Michigan Avenue & Irving Street NE Mixed Use Complex | Phase 1 & 2

Planned Unit Development
Amended Phase 1 Consolidated Application
June 25, 2015

CASE NO. 08-33C

Changes Reflected in Amended PUD Drawings

Amended B1 Floor Plan

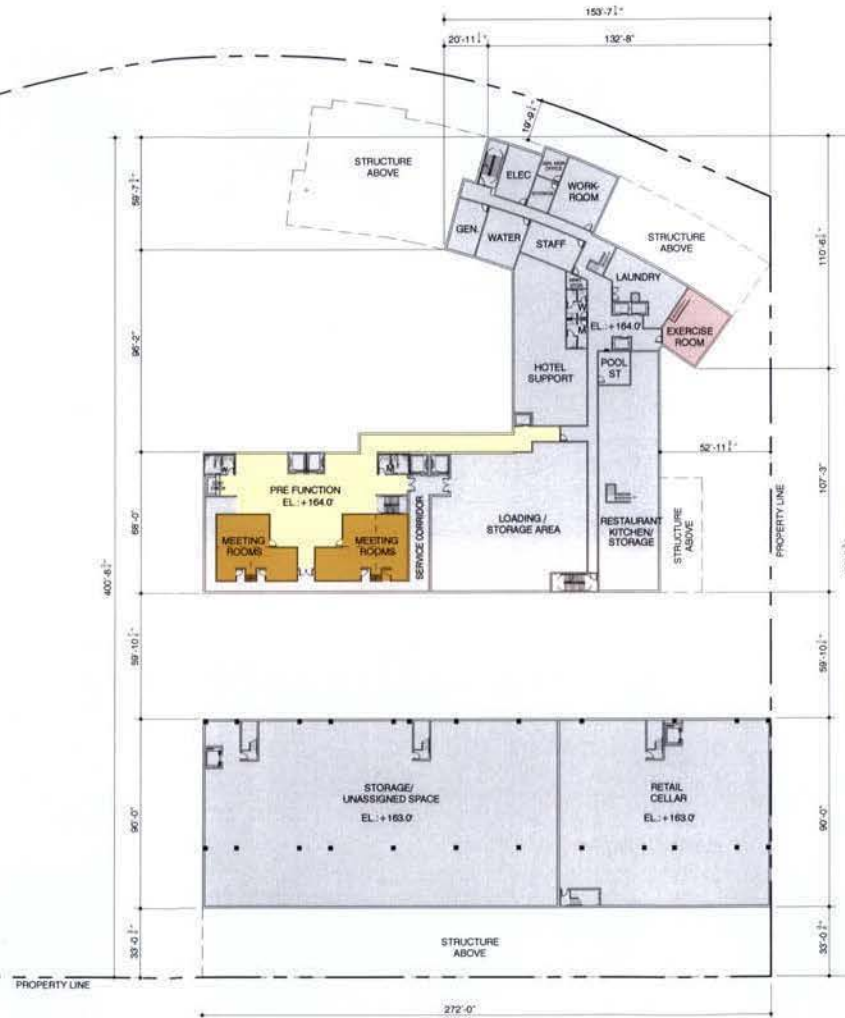
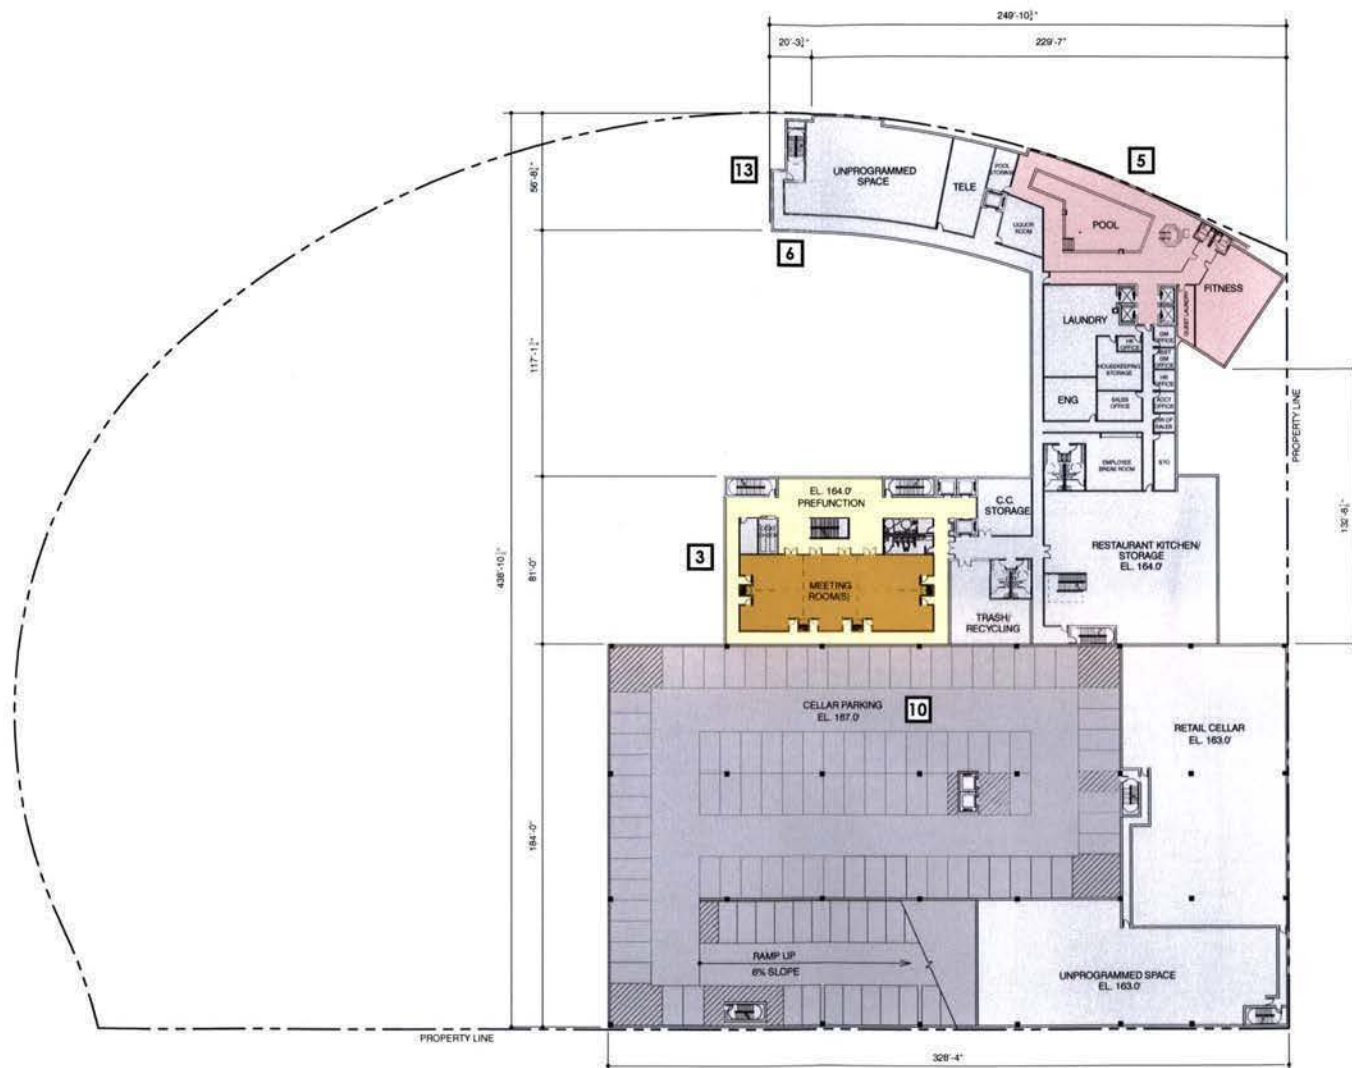
- 3** Increased depth of conference center to create a connection between conference center and hotel
- 5** Extended hotel to property line on Irving Street (no side yard required by zoning)
- 6** Increased basement footprint of hotel to match building footprint above
- 10** Added cellar parking and extended footprint to edge of hotel to provide more parking spaces within the parking garage
- 13** Adjusted hotel footprint to accommodate Marriott Residence Inn & Courtyard design requirements (previously SpringHill Suites)

A-05 Approved Ground Floor Plan

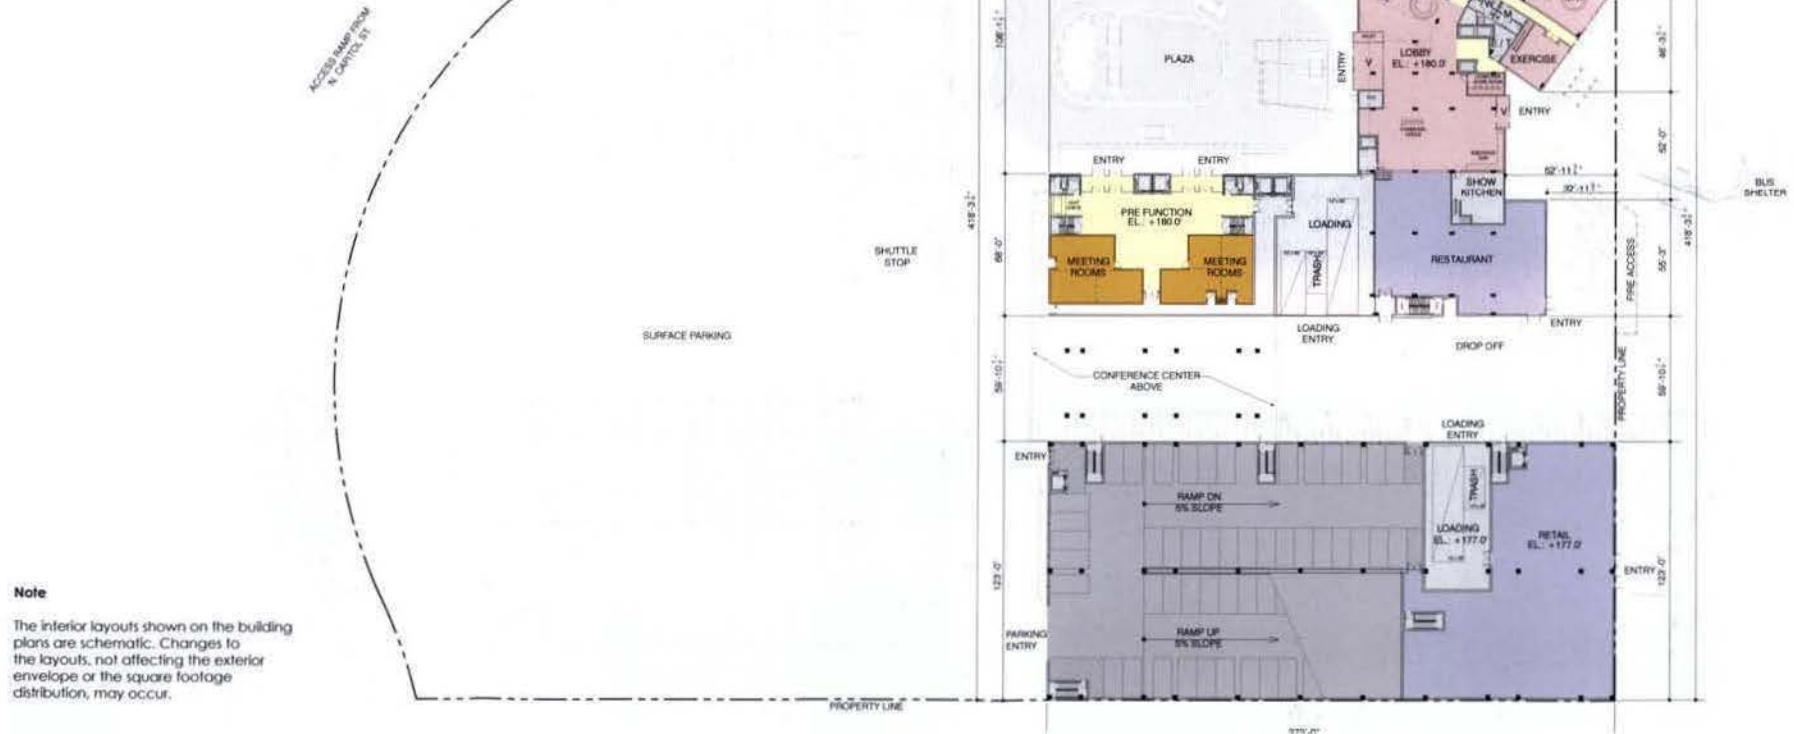
- 2** Increased height of conference center ballroom level, added storefront windows of ground floor, and eliminated columns under conference center to improve pedestrian experience and view corridors for future phase 2 retail
- 3** Increased depth of conference center to create a connection between conference center and hotel
- 5** Extended hotel to property line on Irving Street (no side yard required by zoning)
- 8** Modified landscape on Irving Street to accommodate extension of hotel to property line
- 9** Relocated restaurant entrance adjacent to hotel entrance
- 11** Reduced footprint of above grade parking to maintain the previously approved count of 600 parking spaces
- 13** Adjusted hotel footprint to accommodate Marriot Residence Inn & Courtyard design requirements (previously SpringHill Suites)

Amended Typical Floor Plan

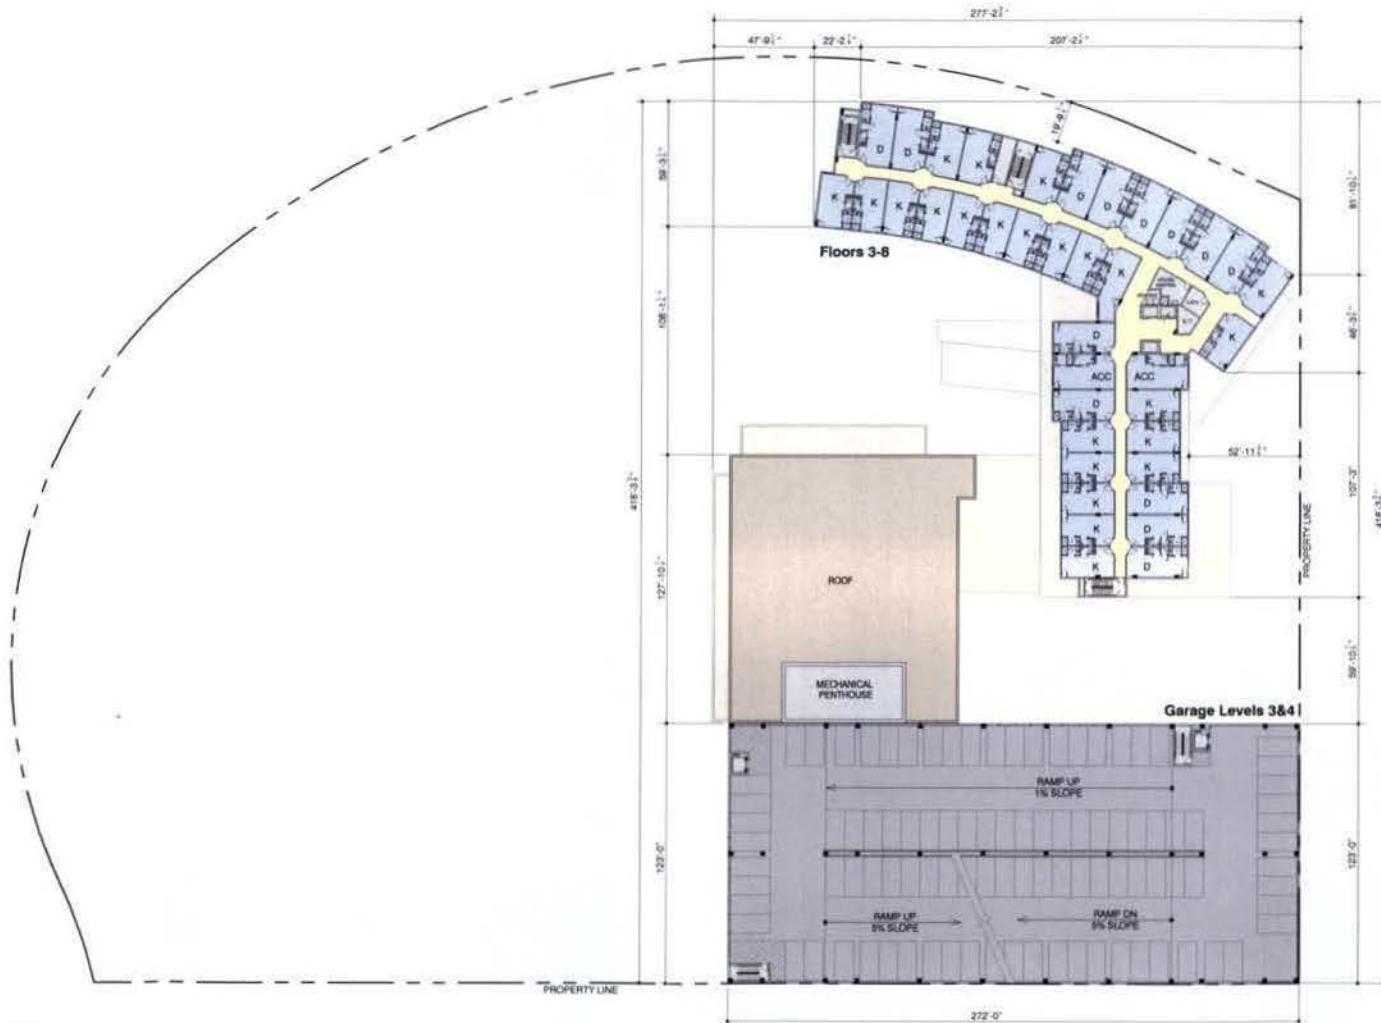
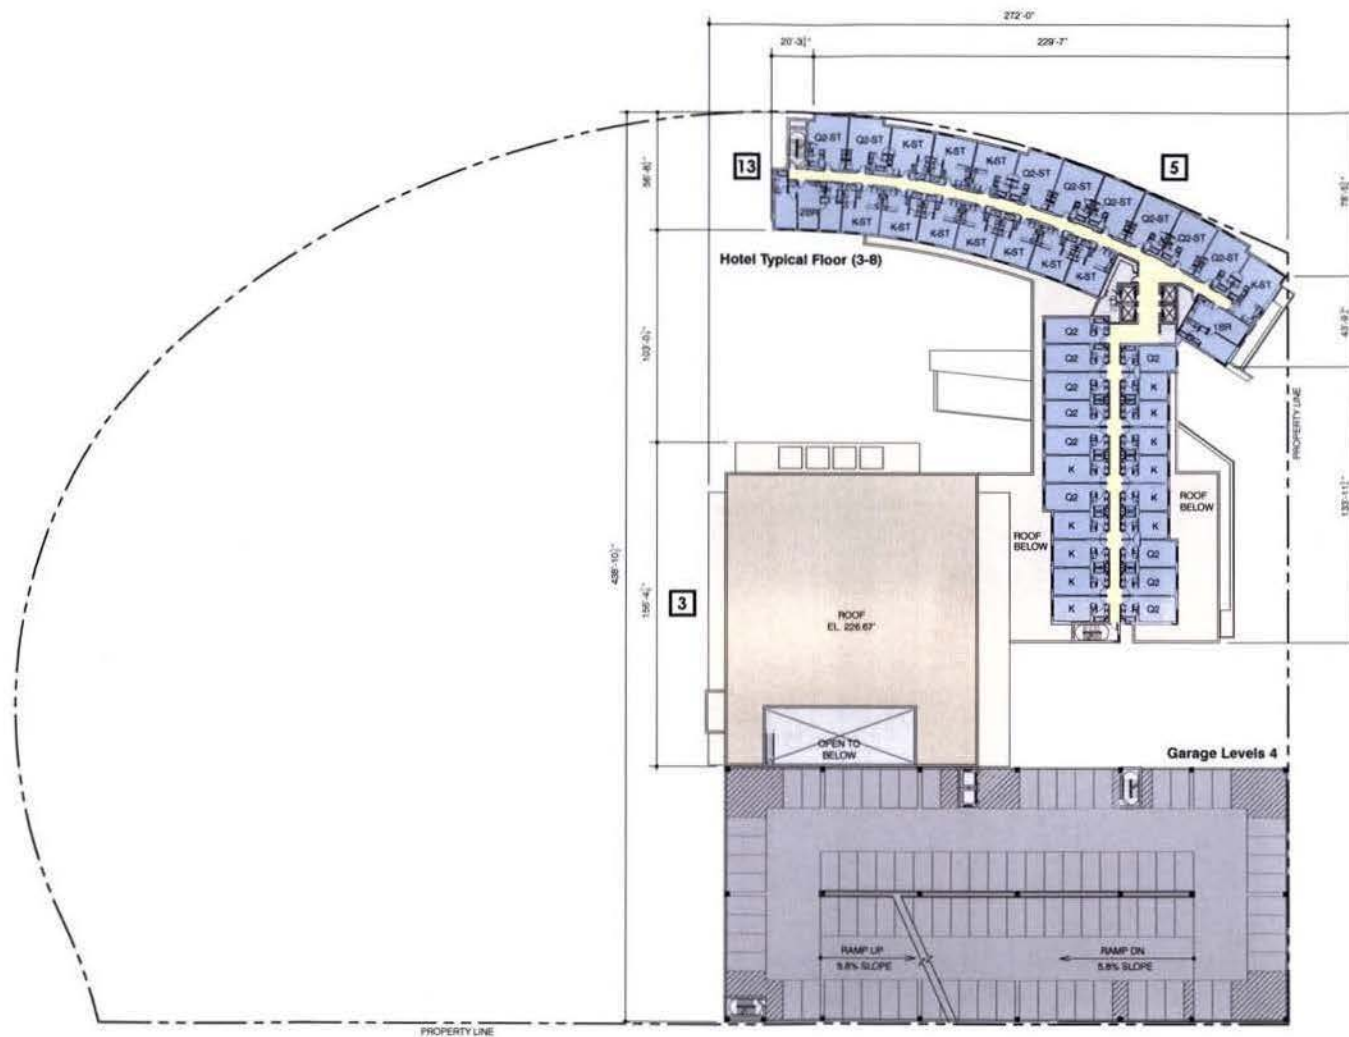
- 3** Increased depth of conference center to create a connection between conference center and hotel
- 5** Extended hotel to property line on Irving Street (no side yard required by zoning)
- 13** Adjusted hotel footprint to accommodate Marriott Residence Inn & Courtyard design requirements (previously SpringHill Suites)

Amended Roof Plan

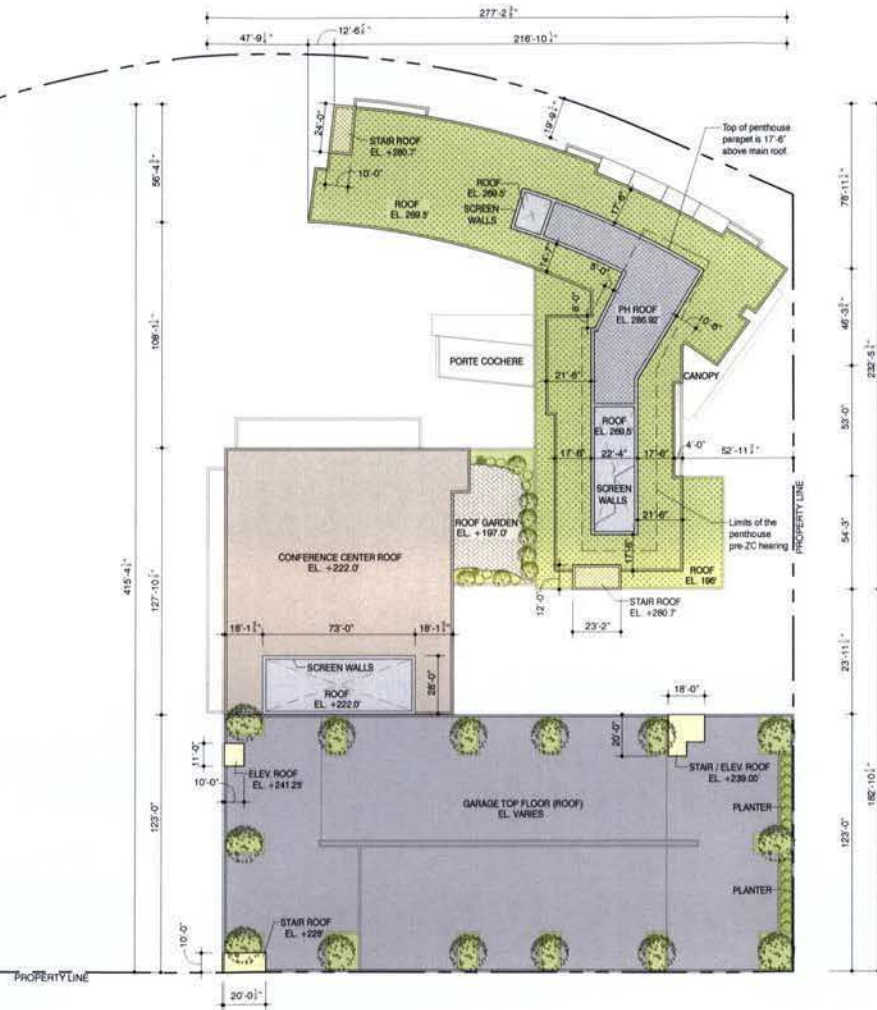
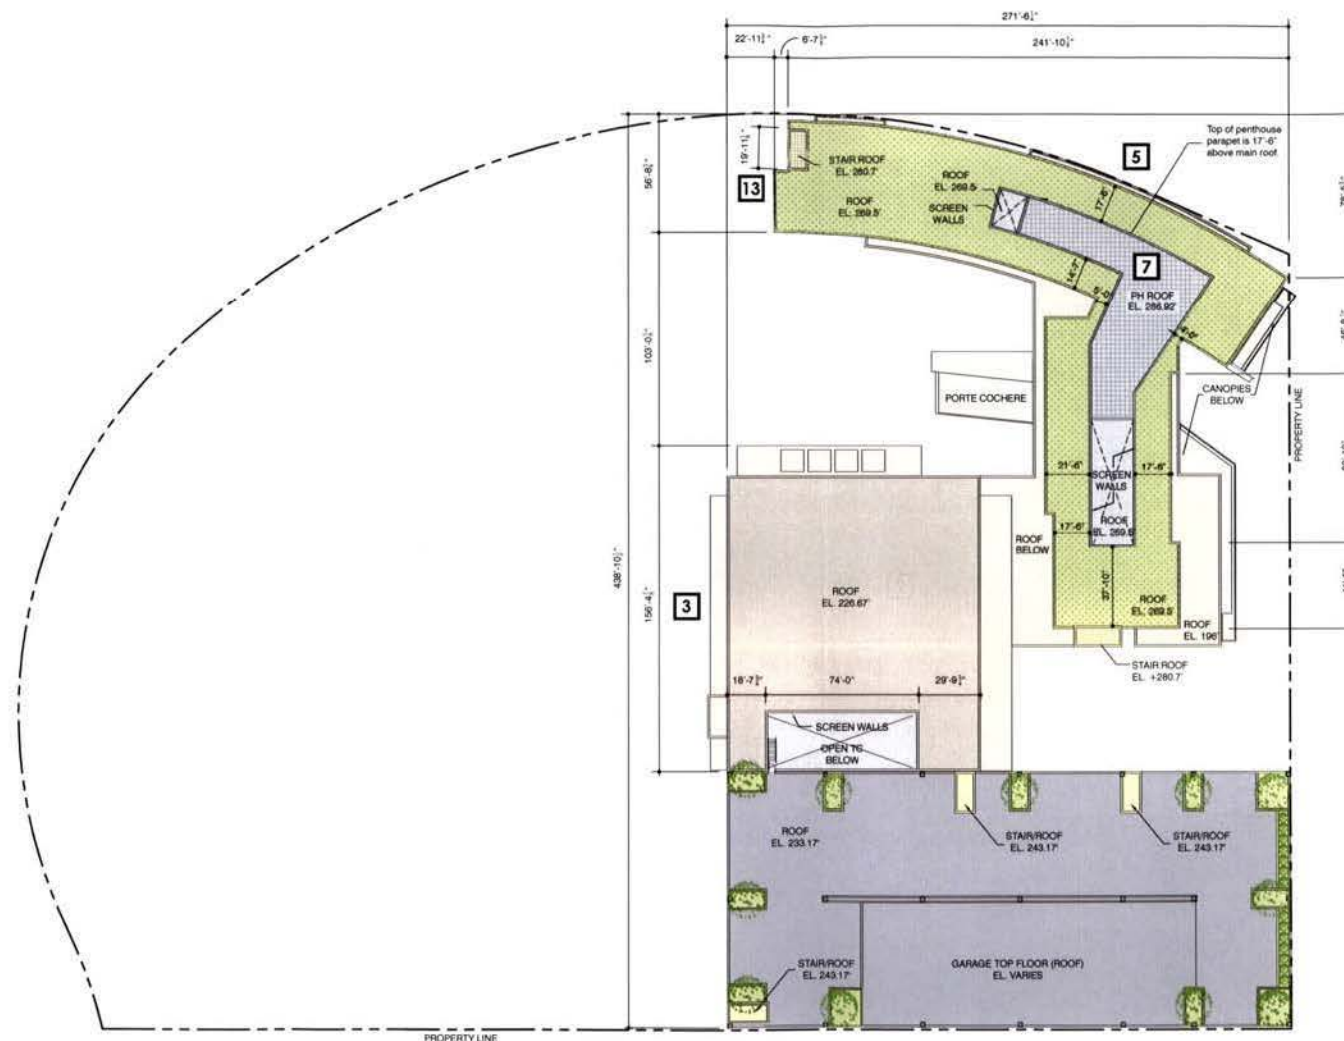
- 3** Increased depth of conference center to create a connection between conference center and hotel
- 5** Extended hotel to property line on Irving Street and increased length of north facade (no side yard required by zoning)
- 7** Modified penthouse structure to accommodate hotel changes (see note 5)
- 13** Adjusted hotel footprint to accommodate Marriott Residence Inn & Courtyard design requirements (previously SpringHill Suites)

A-19 West Elevation

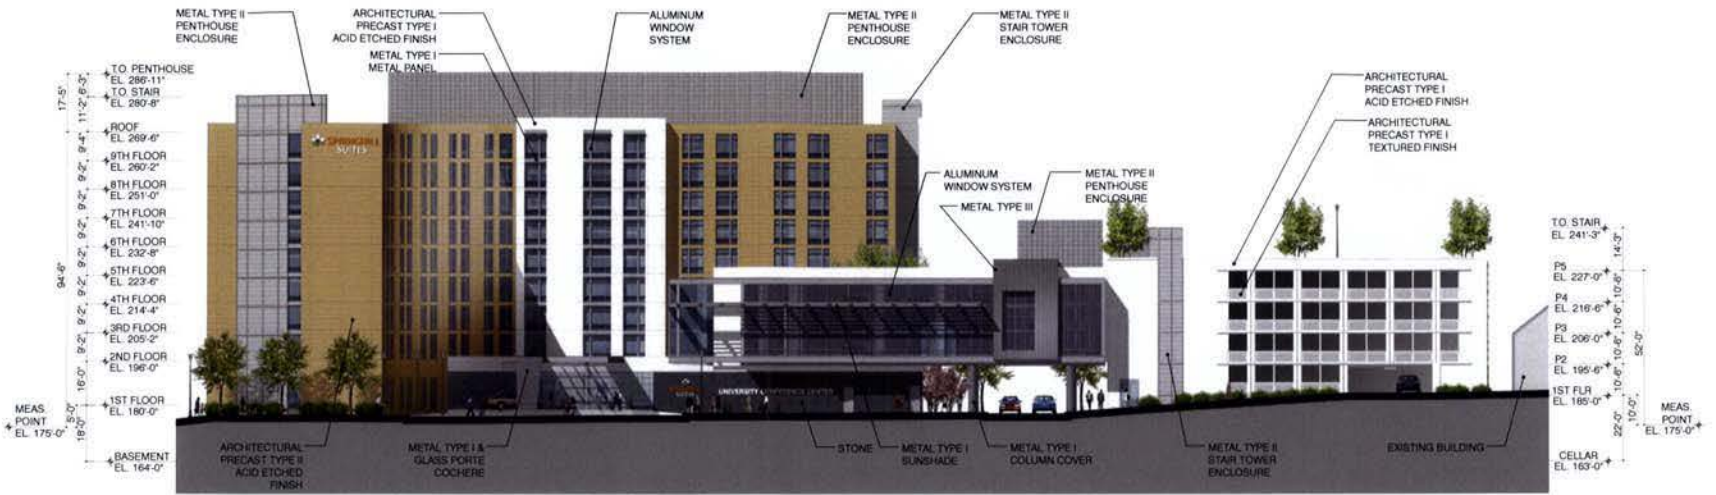
- 2** Increased height of conference center ballroom level, added storefront windows at ground floor, and eliminated columns under conference center to improve pedestrian experience and view corridors for future phase 2 retail.

- 7** Modified penthouse structure to accommodate hotel changes (see note 5).

- 10** Added cellar parking in garage and extended footprint to edge of hotel to provide more parking spaces within the parking structure.

- 13** Adjusted hotel footprint to accommodate Marriott Residence Inn & Courtyard design requirements (previously SpringHill Suites).

A-21 Garage South Elevation

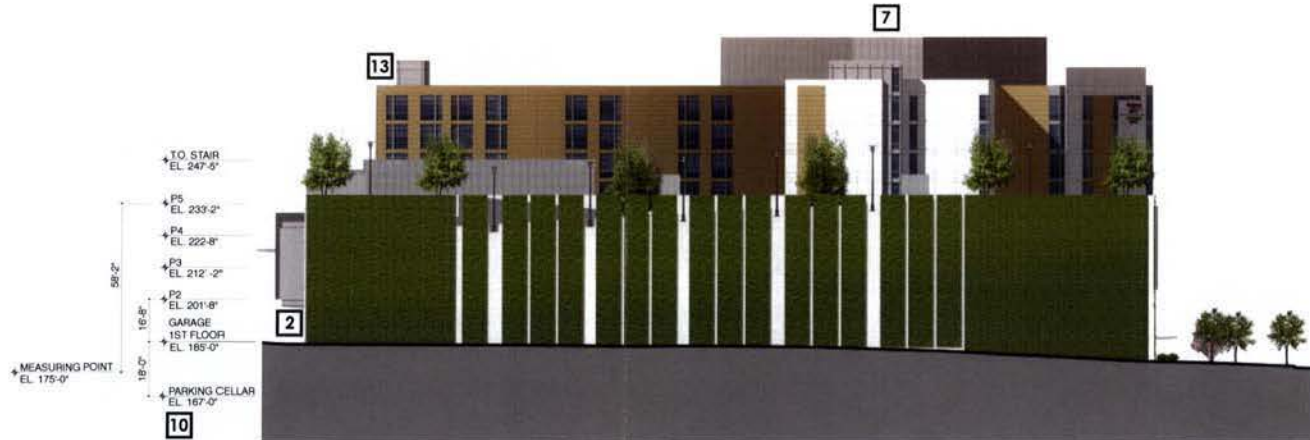
- 2** Increased height of conference center ballroom level, added storefront windows at ground floor, and eliminated columns under conference center to improve pedestrian experience and view corridors for future phase 2 retail
- 7** Modified penthouse structure to accommodate hotel changes (see note 5)
- 10** Added cellar parking in garage and extended footprint to edge of hotel to provide more parking spaces within the parking structure
- 13** Adjusted hotel footprint to accommodate Marriott Residence Inn & Courtyard design requirements (previously SpringHill Suites)
